## Video Products Technical Bulletin 30-2003-231

SUBJECT: PARTS REGISTRATION-BEZEL ASSEMBLY

MODEL: **PVM-20S1WU**

Figure 1

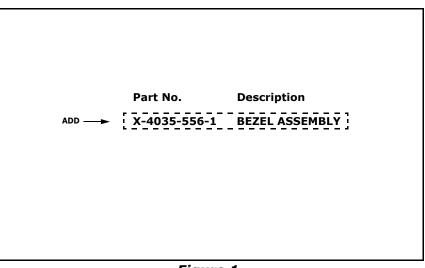
The bezel assembly is now available as service part number **X-4035-556-1**. Correct the *PVM-20S1WU Service Manual*, Supplement-1 as shown in Figure 1.

**NOTE:** If your unit is earlier than serial number 2,010,001 and you use the new bezel assembly, you must replace the H board (A-1372-477-A).
